**TYEE STATION SERVICE SWITCHGEAR & 15kV GENERATOR CONSTRUCTION PROJECT**

**ADDENDUM NO. 1**

**Date:** March 26, 2024

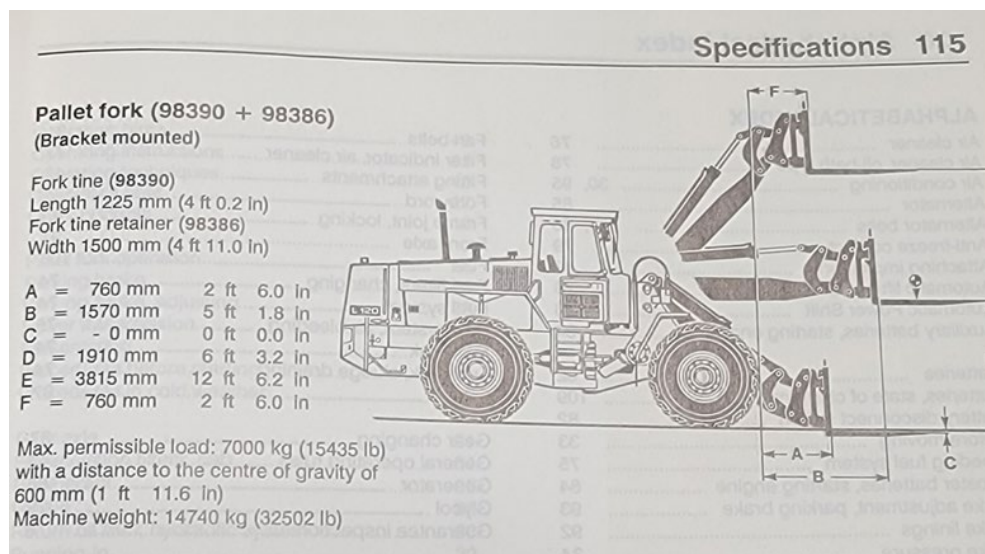
2. Regarding the existing equipment slated to be removed from the powerhouse, could you please provide a list of equipment, annotated with estimated weights? Especially interested in the station transformers and existing generator(s).

**SEAPA RESPONSE: The heaviest items to be removed include:**

- **Diesel Generator:** original prints show it on a skid with a 250-gallon fuel tank at a (wet) weight of about 12,500 lbs. Note: fuel tank is not the same as was shown on the original prints (see Fuel Tank response below).
- **Two Station Service Transformers:** weigh 6,280 lbs. each. Note: these are dry-type transformers.
- **15kV Gear:** Located on 3<sup>rd</sup> deck and remaining station service gear can be split apart into sections so are likely not more than a few hundred pounds once the breakers are removed.

- **Fuel Tank:** There is no 250-gallon fuel tank on a skid. The actual fuel tank is approximately a 750 gallon tank housed in a building extension (see pictures below). It will not fit out the door of the building extension. The Contractor will likely choose to cut the tank into pieces to remove. SEAPA will remove the fuel from the tank to the extent possible before work begins. Contractor will be responsible for residual sludge and/or diesel if any is present in very bottom of tank.

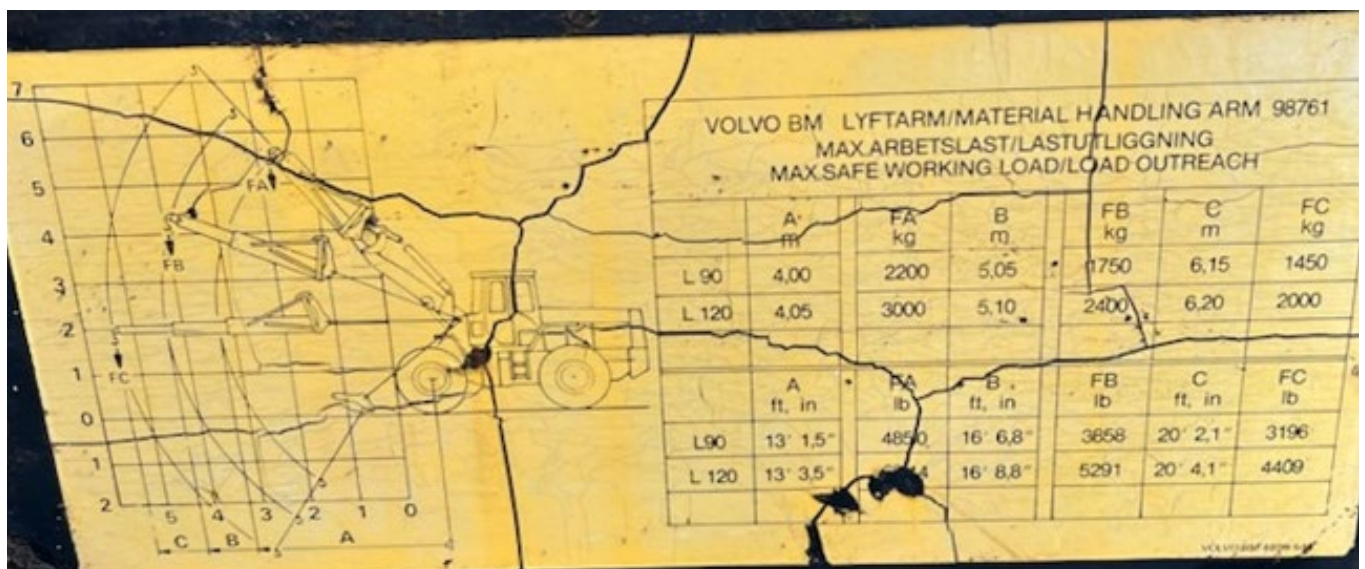
3. Does SEAPA have on-site equipment capable of loading/offloading from the barge? If yes, please provide weight restrictions.

**SEAPA RESPONSE:** There is a Volvo L120 Loader on site with forks (picture from Operating Manual):

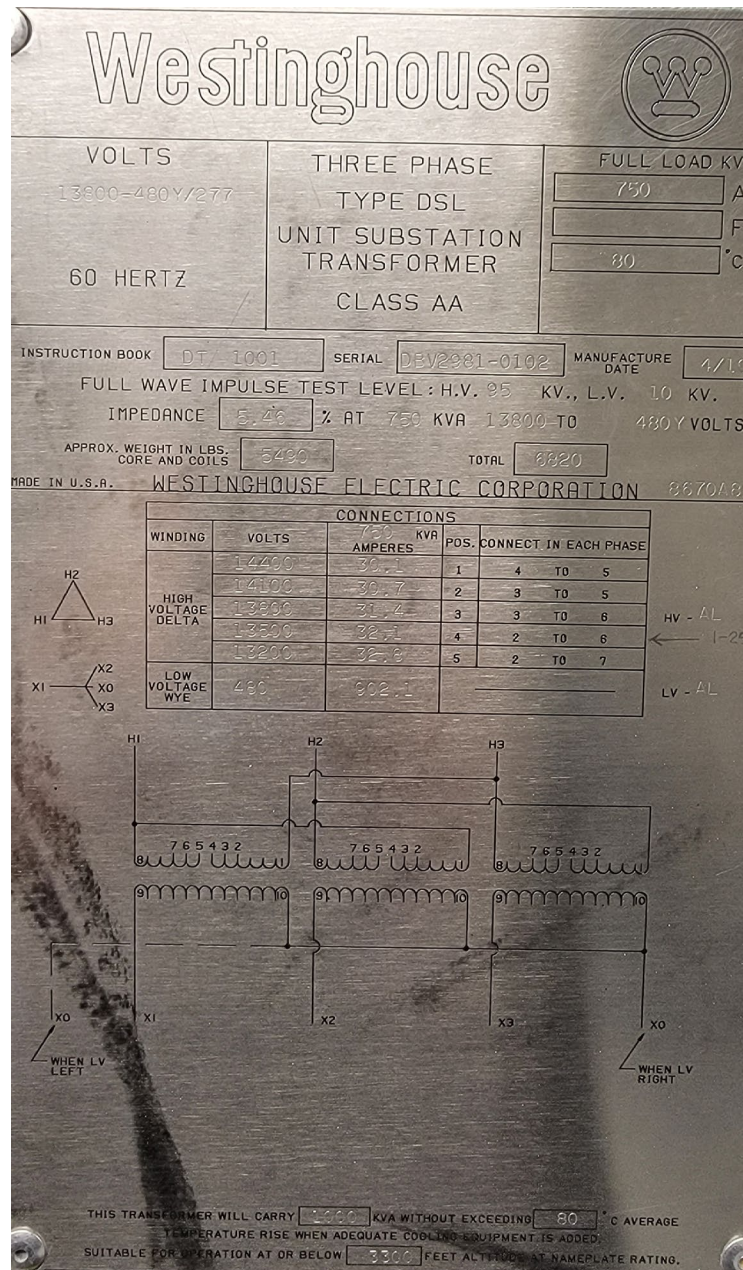
5. Has any testing been performed on the existing station transformers to determine PCB status?

**SEAPA RESPONSE:** The station service transformers are the dry type. The following is the transformers’ name plate:
